## NEW MEXICO ENVIRONMENT DEPARTMENT

**Re: New Mexico State Police District 7 Headquarters; Construction General Permit (CGP);  
NMU001941; SIC 1592; August 9, 2017**

### NPDES Compliance Inspection Report

**New Mexico General Services Department**  
**Project: NEW MEXICO STATE POLICE, DISTRICT 7 HEADQUARTERS**  
**NPDES Compliance Evaluation Inspection**  
**NPDES Permit NMU001941**  
**Inspection Date: August 9, 2017**

NMED/SWQB  
OFFICIAL PHOTO LOG  
PHOTO #2

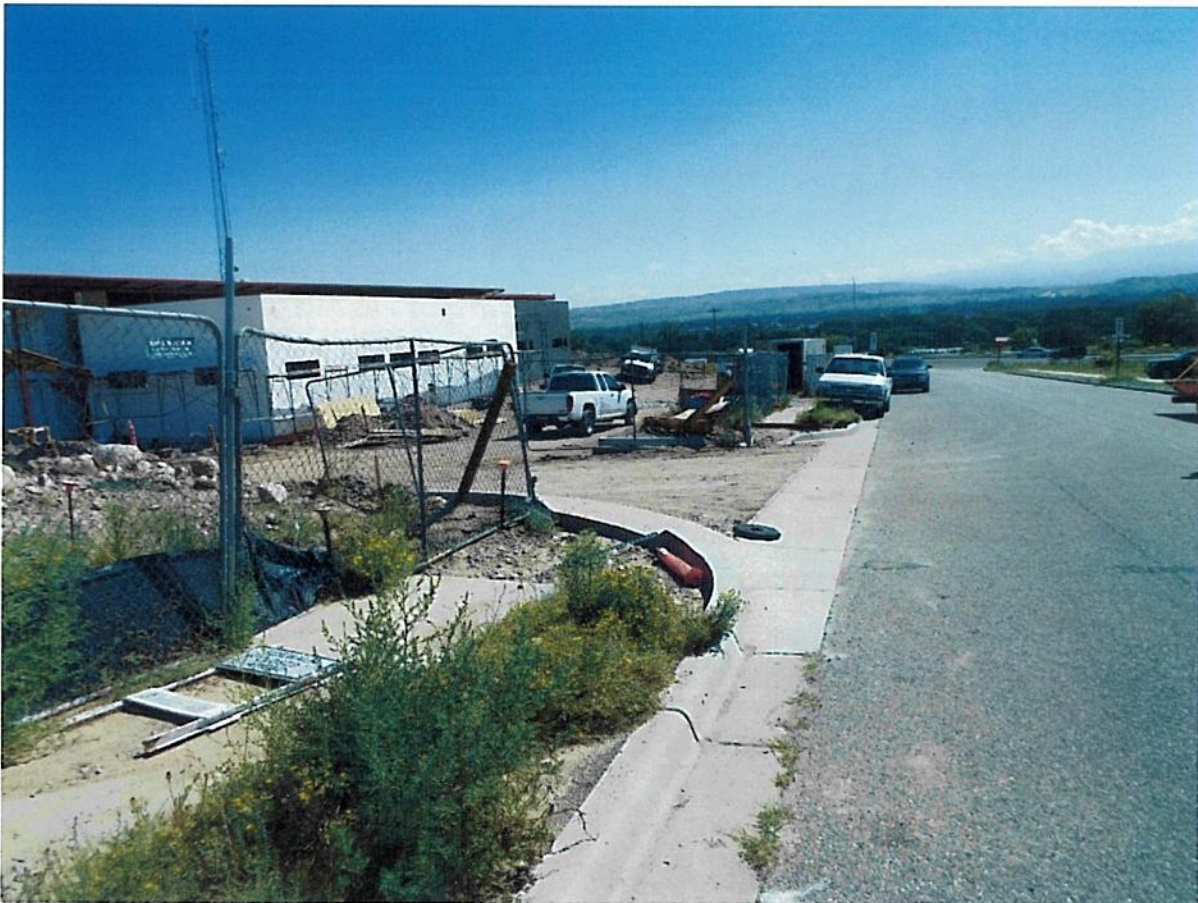
Photographer: Daniel Valenta	Date: August 9, 2017	Time: 1046 Hours
City/County: Espanola/Rio Arriba		
Location: New Mexico State Police District 7 Headquarters		
Subject: One of two entrances on site. (southwest entrance) Part 2.2.4/Permit Requirements: Use appropriate stabilization techniques (e.g., use of aggregate stone with an underlying geotextile or non-woven filter fabric, and turf mats) at all points that exit onto paved roads.

**NMED/SWQB  
OFFICIAL PHOTO LOG  
PHOTO #4**

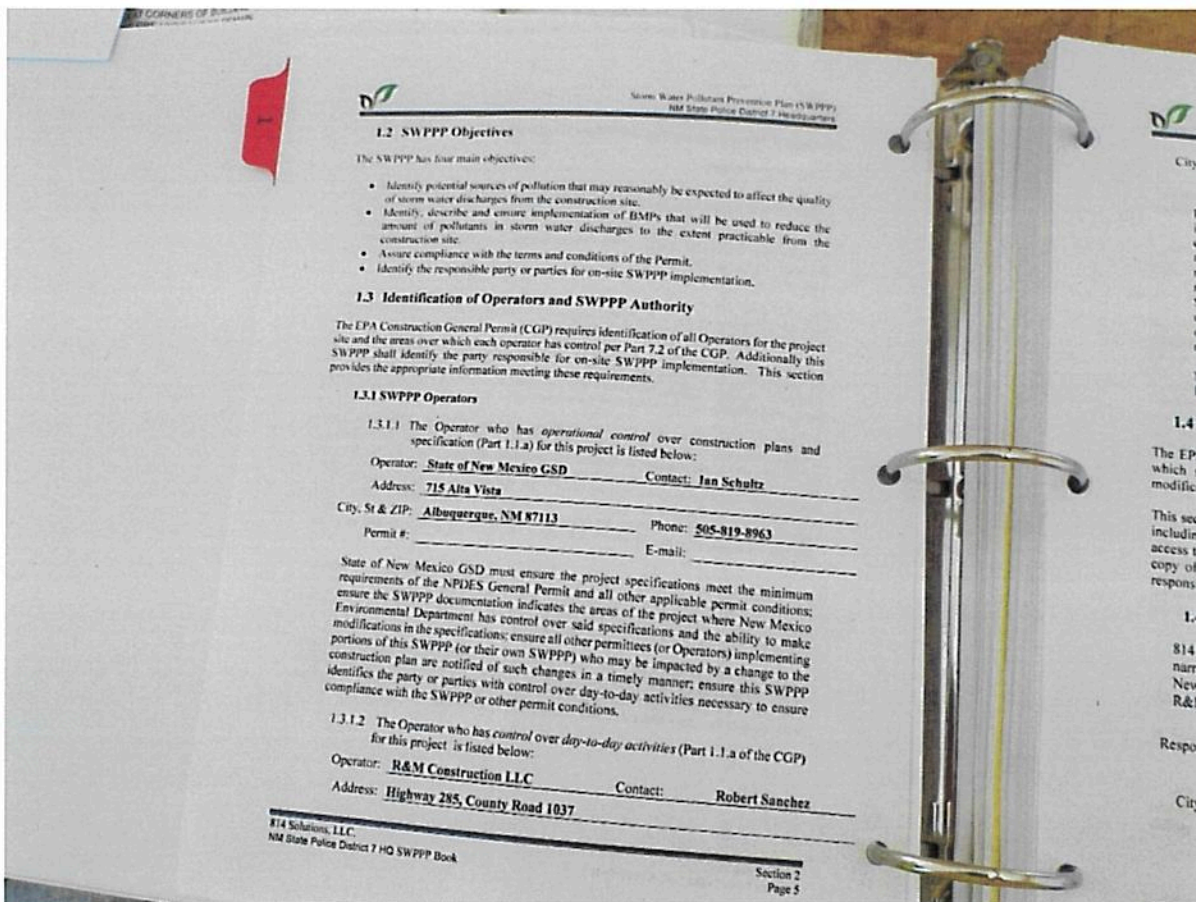
Photographer: Daniel Valenta	Date: August 9, 2017	Time: 1046 Hours
City/County: Espanola/Rio Arriba		
Location: New Mexico State Police District 7 Headquarters		
Subject: Page 5 of SWPPP – SWPPP Owner (operational control of construction / Contractor (day to day activities at site) listed.

NMED/SWQB  
OFFICIAL PHOTO LOG  
PHOTO #13

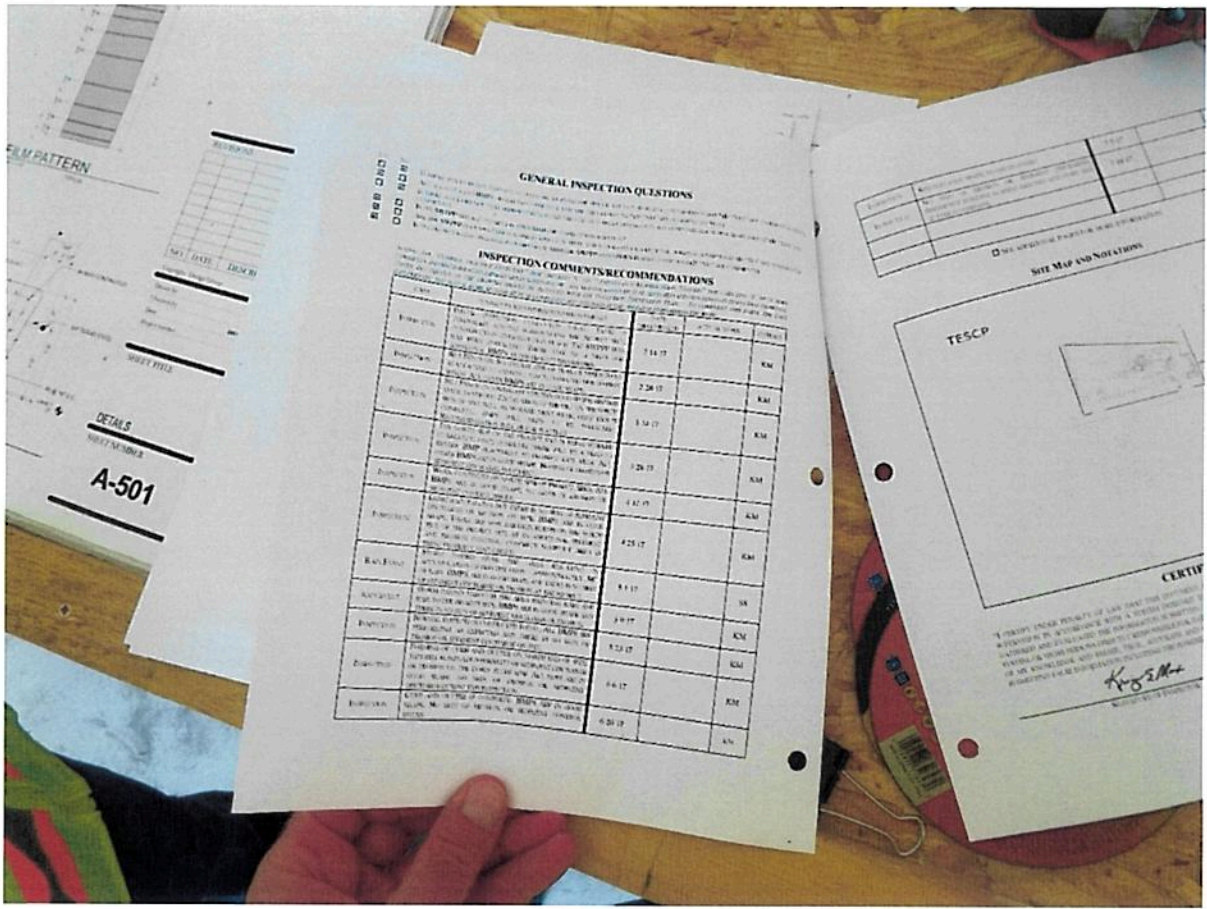
The first site inspection by 814 Solutions (sub-contractor), after construction began, was completed on February 14, 2017 by Mr. Craig Max, Environmental Compliance Manager. This site appears to have been active for approximately six months without a permit. Inspections, provided in the SWPPP, indicate that there was a precipitation event that occurred on May 1, 2017, with an accumulation of .58" of rain. There was not an inspection done 24-hours following this event, as required by the permit. The next inspection was dated May 9, 2017 (see photo #13).

Photographer: Daniel Valenta	Date: August 9, 2017	Time: 1132 Hours
City/County: Espanola/Rio Arriba		
Location: New Mexico State Police District 7 Headquarters		
Subject: Inspection report. Part 4.2 of Permit Requires: Inspect <b>within 24 hours</b> of the occurrence of a storm event of 0.25 inches or greater. (Rain event on May 1, 2017 of .58")
